UNITED STATES
NUCLEAR REGULATORY COMMISSION
WASHINGTON, D. C. 20555

NOV 16 1978

SUBJECT: IMPLEMENTATION OF STAFF REVIEW REQUIREMENTS - RIVER BEND
STATION, UNITS 1 AND 2

FIG 1. PROPOSED DUCTILITY RATIOS FOR BEAM COLUMNS

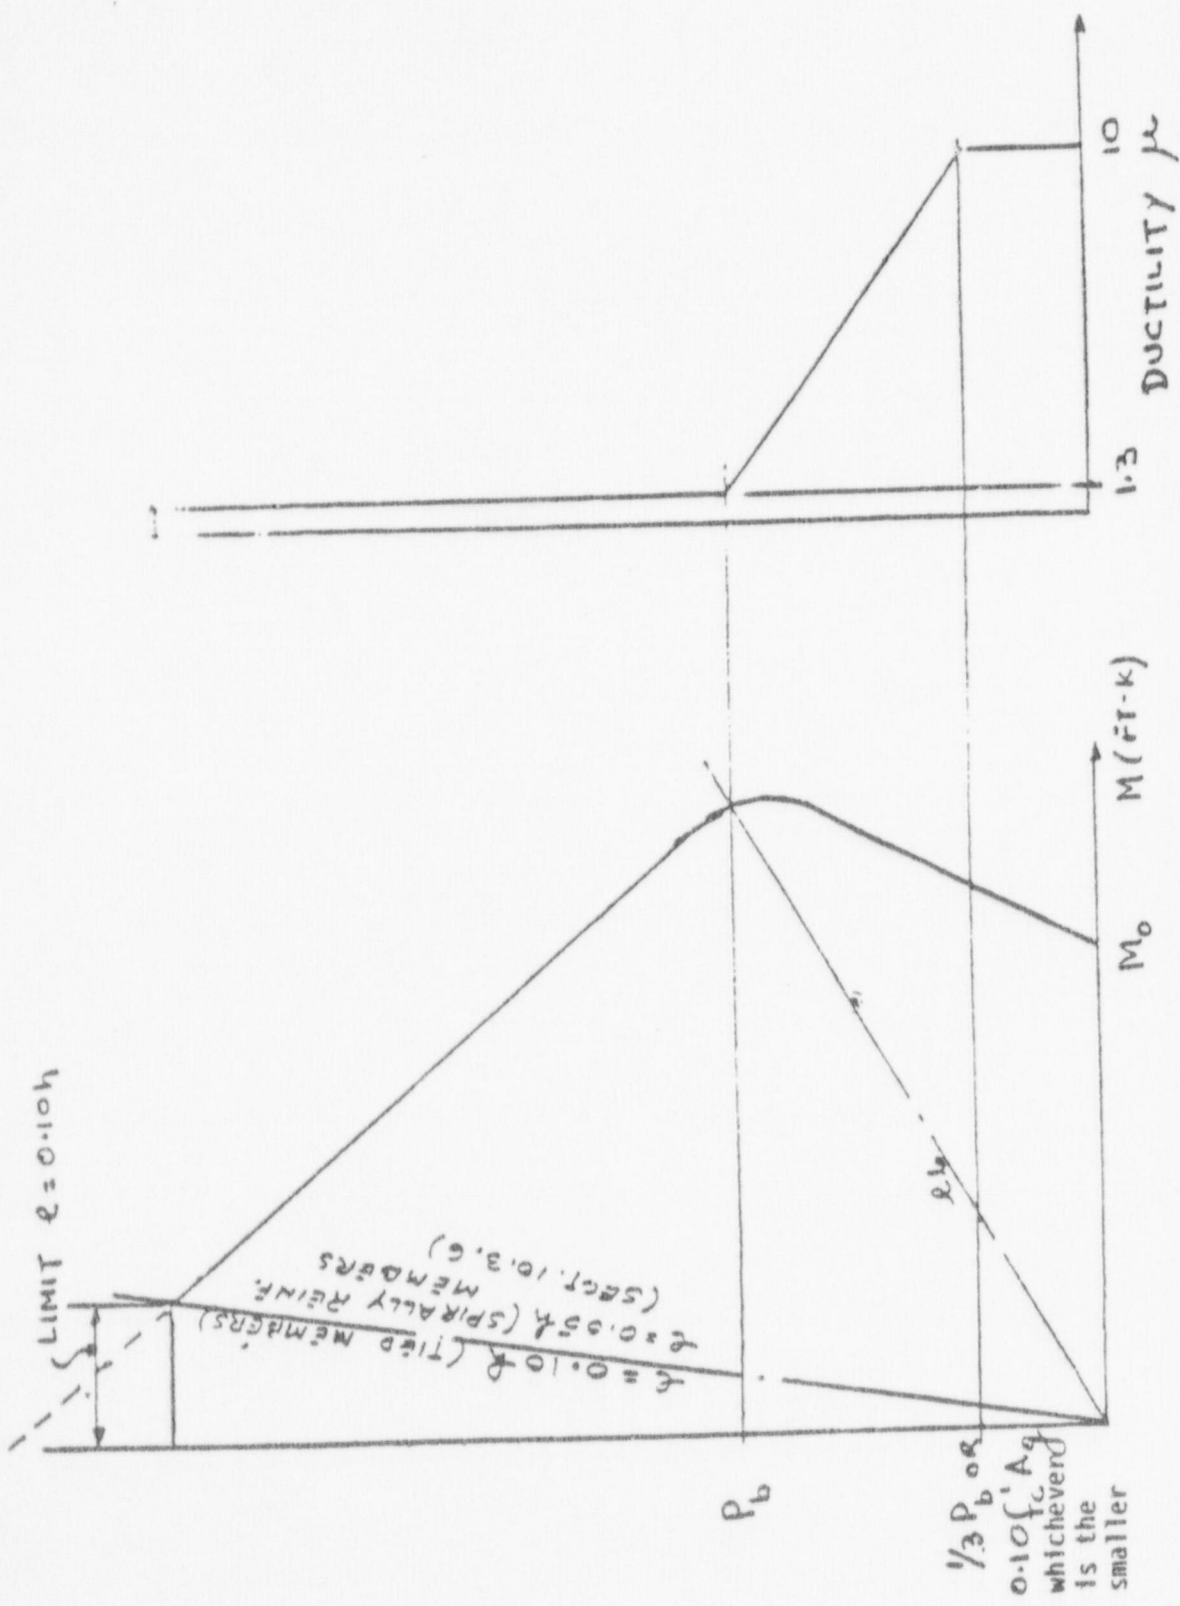
- 1.3 For beam-columns, walls, and slabs carrying axial compression loads and subject to impulsive or impactive loads producing flexure, the permissible ductility ratio in flexure should be as follows:

- (a) When compression controls the design, as defined by an interaction diagram, the permissible ductility ratio shall be 1.3.
 - (b) When the compression loads do not exceed $0.1f_c'Ag$ or one-third of that which would produce balanced conditions, whichever is smaller, the permissible ductility ratio can be as given in Section 1.1.

- (c) The permissible ductility ratio shall vary linearly from 1.3 to that given in Section 1.1 for conditions between those specified in (a) and (b). (See Fig 1.)
